CHANGE ORDER APPROVAL FORM

PROJECT: Part A - Lift Station No. 1 + Part B - Lift Station No. 3
West Nassau Landfill Flare Station Blower System Replacement CHANGE ORDER: 1

CONTRACT NUMBER: CM2301

CHANGE ORDER REQUEST FORM

CO No. 4: Gravel Surface at Lift Station 3

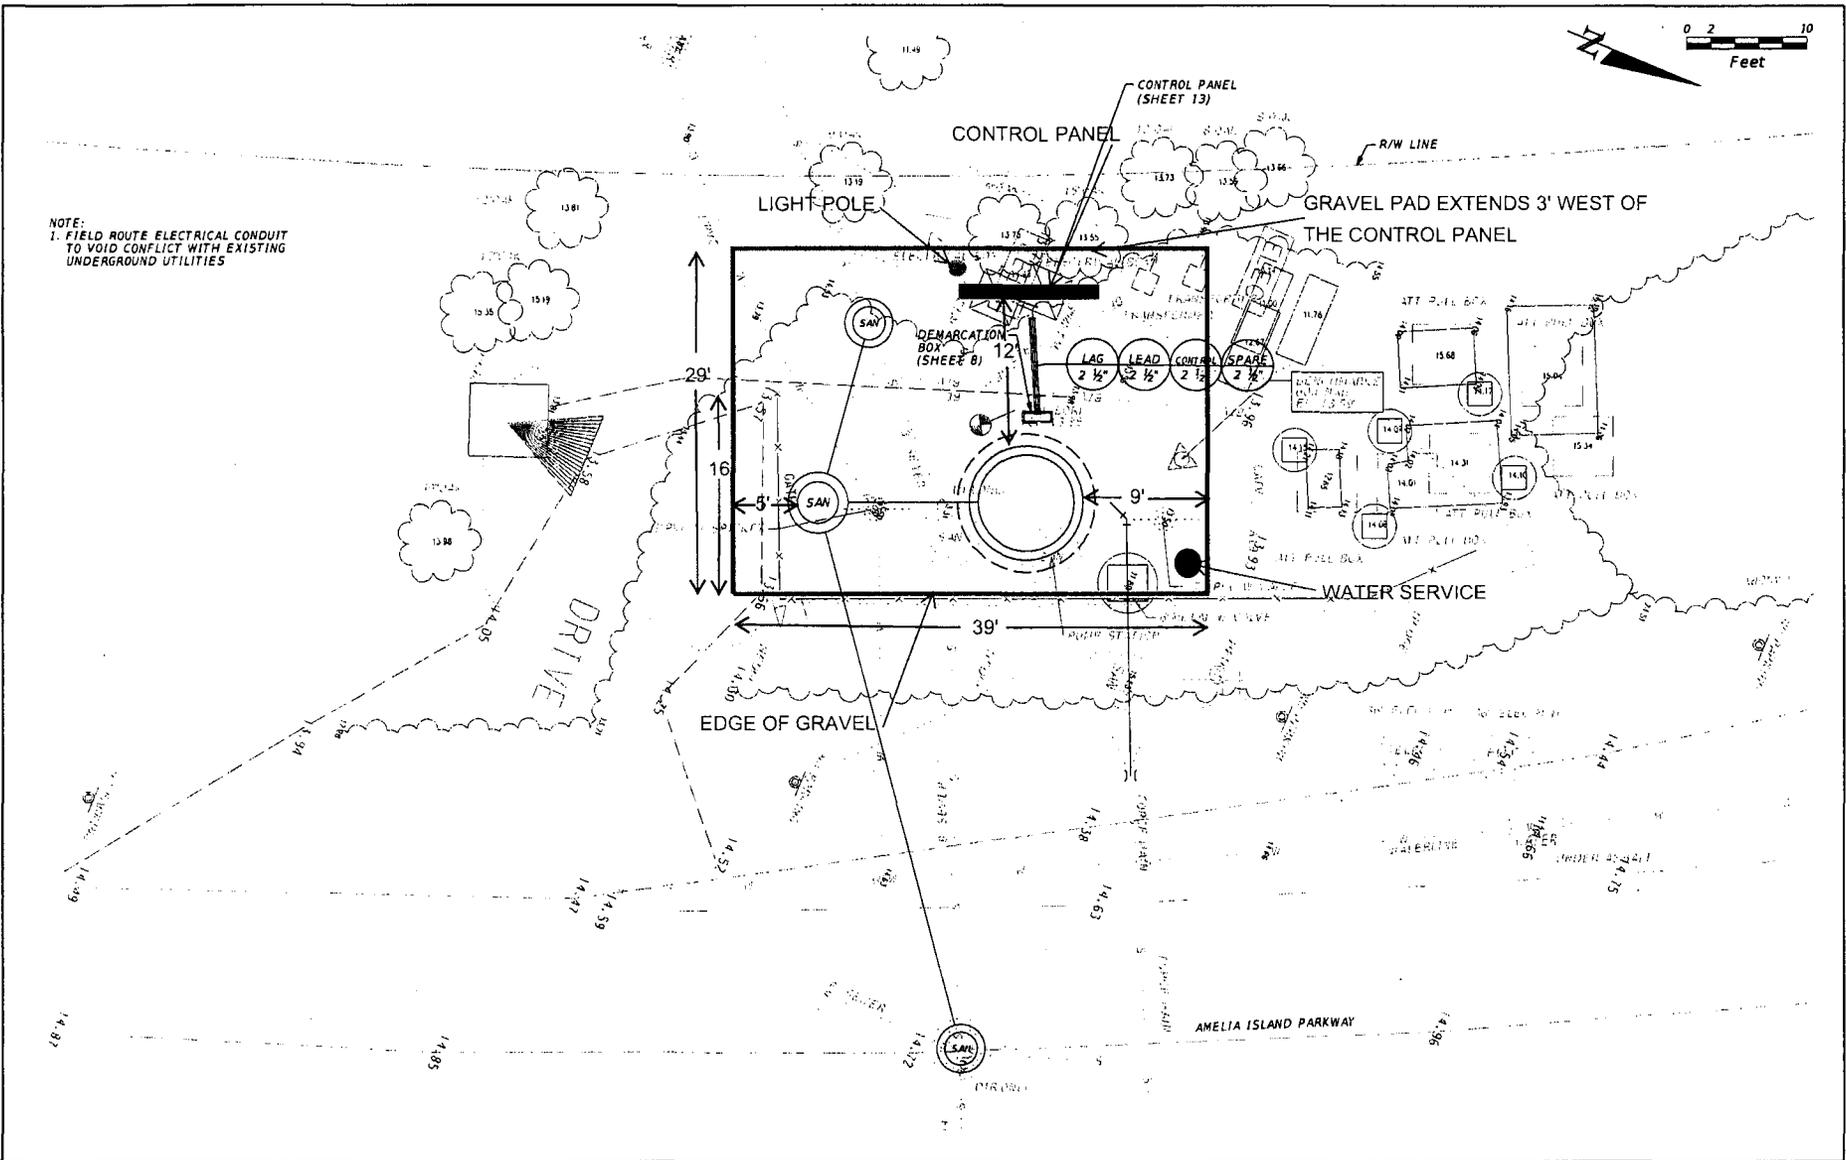
Install a 6" layer of gravel (#57 stone) around the wet well at the Lift Station 3 site. The area to cover with gravel is approximately 29' x 39'.

A 10 mil plastic sheeting will be installed on the finished dirt surface and 6" of gravel will be installed on top of the plastic.

Please see the attached change order proposal for the gravel installation at Lift Station 3. A drawing is also attached that shows the outline of the proposed gravel pad as well as a proposed locations for the light pole and water service.

CONTRACTOR REQUEST FOR INFORMATION NO.: 6

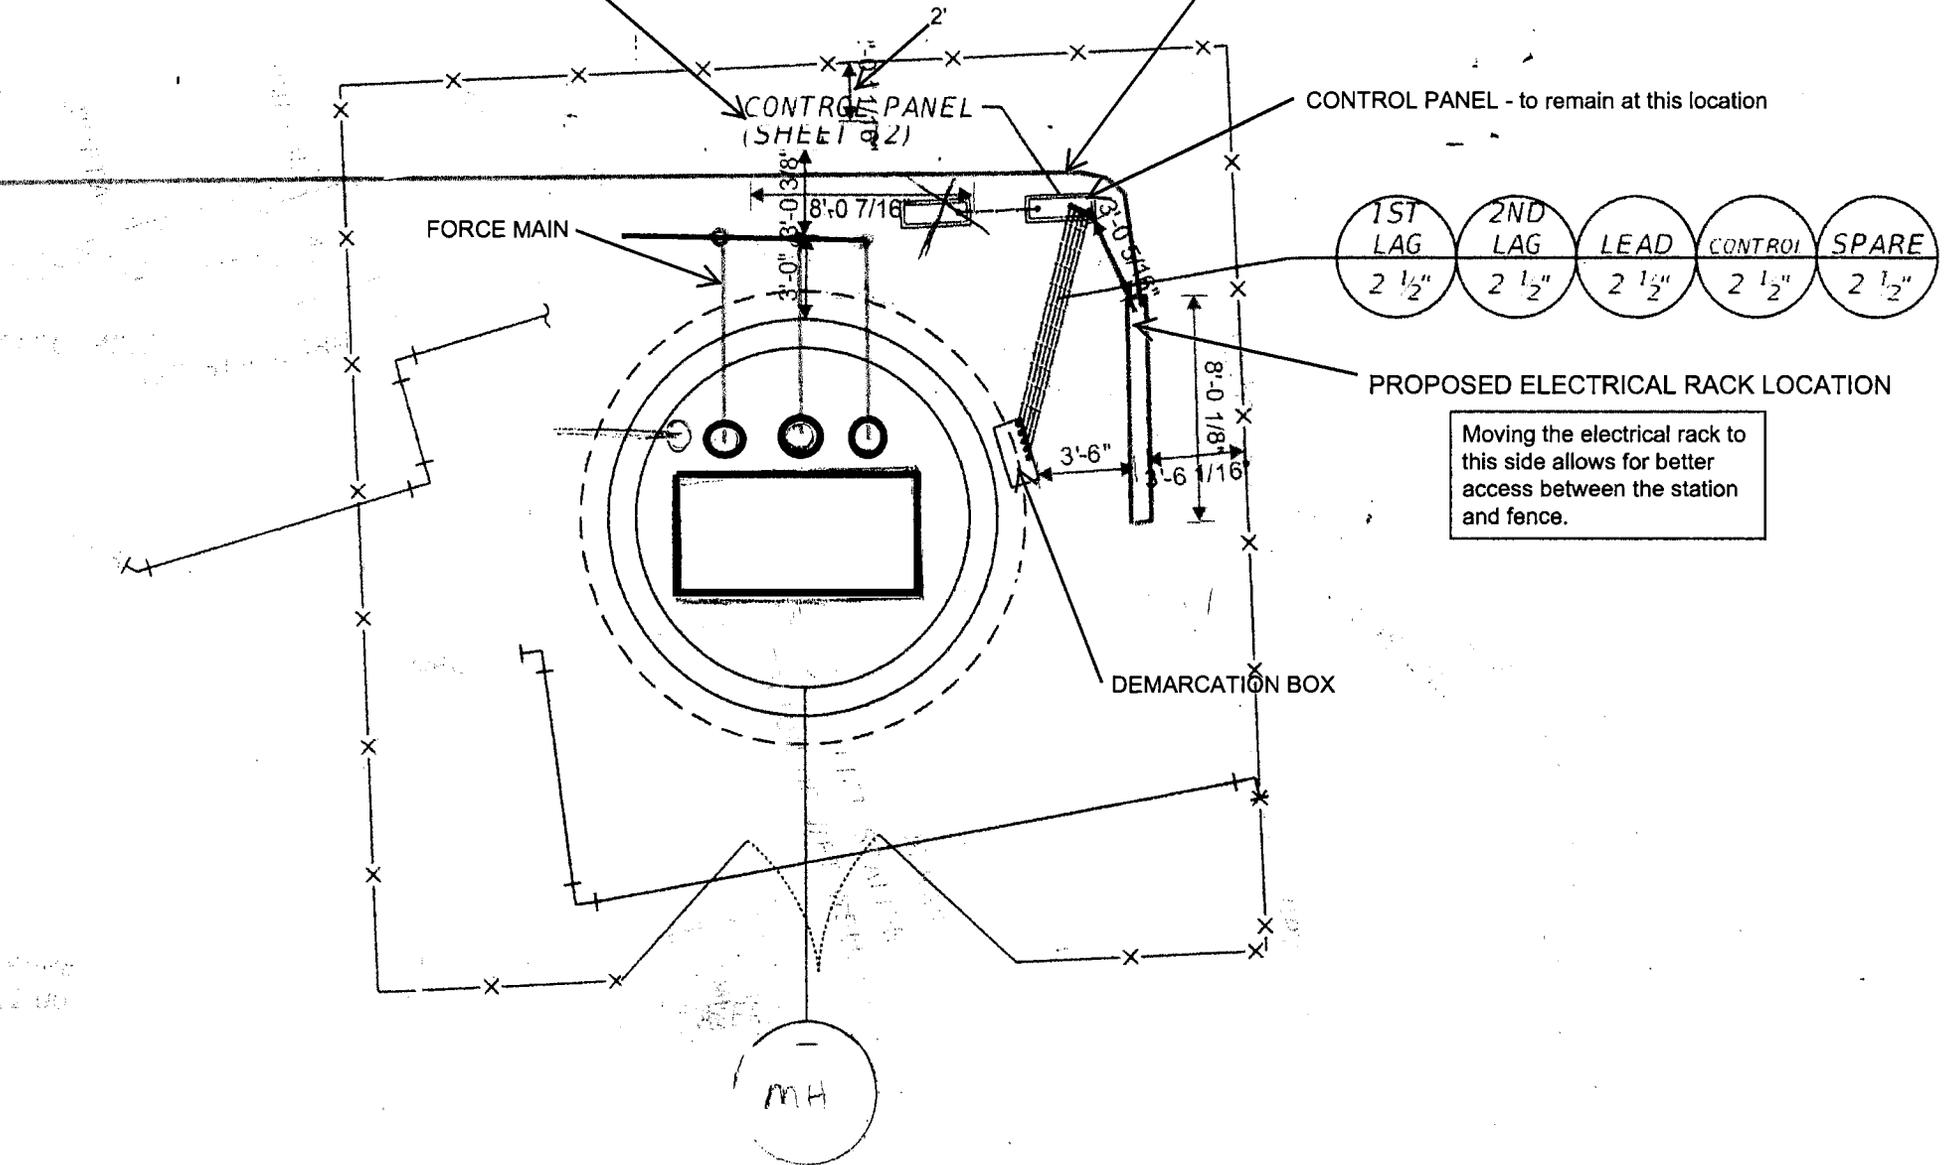
Can the electrical rack be moved to the north side of the wet well?
Moving the rack as shown on the attached drawing will allow for better access around the station. If the rack was to
be installed per plan it would not have the required clearances from the force main pipes as they enter the ground in front
of the rack. Moving the rack back away from force main will put it at 2' or less off of the fence and limits access around
the station and force main.
The actual length of the rack is 8' wide which is larger than what is shown on the plan.

ACTUAL LOCATION OF ELECTRICAL RACK (if rack was to be installed on this side)
 IN ORDER TO OBTAIN REQUIRED CLEARANCES

Moving the electrical rack to this side allows for better access between the station and fence.

We have no objections.
